Access Compliance Report

Public Rights-of-Way

(Curb Ramps)

Intersection ID: 11685	Main Street: E_19TH_ST	Cross Street: SEIGLE_AV	Location: E
ADA ID: 2CF936627B27	Ramp Type: BlendTrans1	Initial Pass/Fail: Fail	Overall Compliance: No
Severity Score: 12.5			
Codes/Mitigation Info/Possible Solution		Field Measurements/Component Compliance

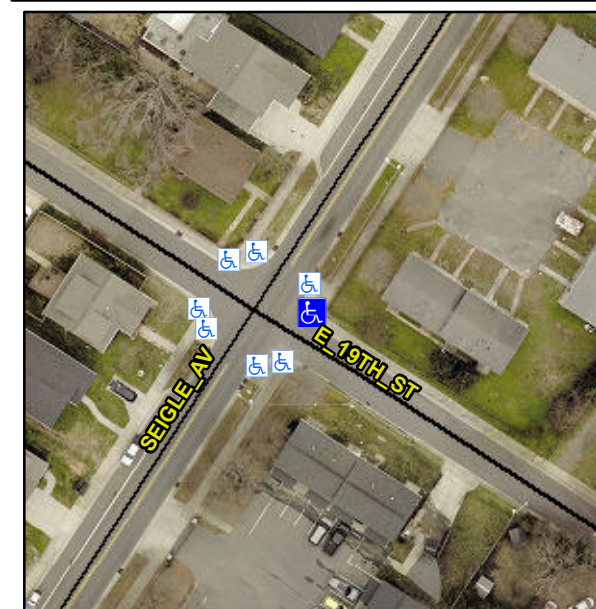
Not Found, R304.5.3

Compliance	Description	Data	Compliance	Description	Data
N/A	Ramp Length (in)	56.0	Yes	BlendTrans Slope (%)	0.4
Yes	Ramp Width (in)	48.0	No	BlendTrans XSlope (%)	6.5
N/A	Flare Type LT	N/A	N/A	Flare Type RT	N/A
N/A	Flare Slope LT (%)	N/A	N/A	Flare Slope RT (%)	N/A
N/A	Flare Traversable LT?	N/A	N/A	Flare Traversable RT?	N/A
N/A	Landing Length (in)	N/A	N/A	DWS Provided?	N/A
N/A	Landing Width (in)	N/A	N/A	DWS Contrast?	N/A
N/A	Landing Slope (%)	N/A	N/A	DWS Length (in)	N/A
N/A	Landing X Slope (%)	N/A	N/A	DWS Full Width?	N/A
N/A	Landing Curb? (Y/N)	N/A	N/A	DWS Offset (in)	N/A
N/A	Shared Landing?	N/A			
N/A	Gutter Ponding?	N/A	N/A	Gutter Slope (%)	N/A
N/A	Gutter Lip Ht (in)	N/A	N/A	Gutter X Slope (%)	N/A
N/A	Painted X Walk1?	No	N/A	Painted X Walk2?	N/A
	X Walk 1 Direction	To SW		X Walk 2 Direction	N/A
	X Walk 1 Width (in)	N/A		X Walk 2 Width (in)	N/A
	X Walk 1 Slope (%)	3.1		X Walk 2 Slope (%)	N/A
	X Walk 1 X Slope (%)	3.6		X Walk 2 X Slope (%)	N/A

N/A	Ramp inside XWalk1?	N/A	N/A	Ramp inside XWalk2?	N/A
	Road Slope (%)	3.6		Clear Space?	N/A
	Road X Slope (%)	3.1	N/A	Clear Space to XWalk (in)	N/A
N/A	Any Obstructions?	N/A	N/A	Storm Grate/Utility Hazard?	N/A
	Obstruction Type			Storm Grate/Utility Type	
		N/A			N/A
			Yes	Surface Condition? (G/P)	Good
			No	Curb Slope (%)	10.2

Remove & Replace Curb Ramp With Two New Directional Ramps or Equivalent.
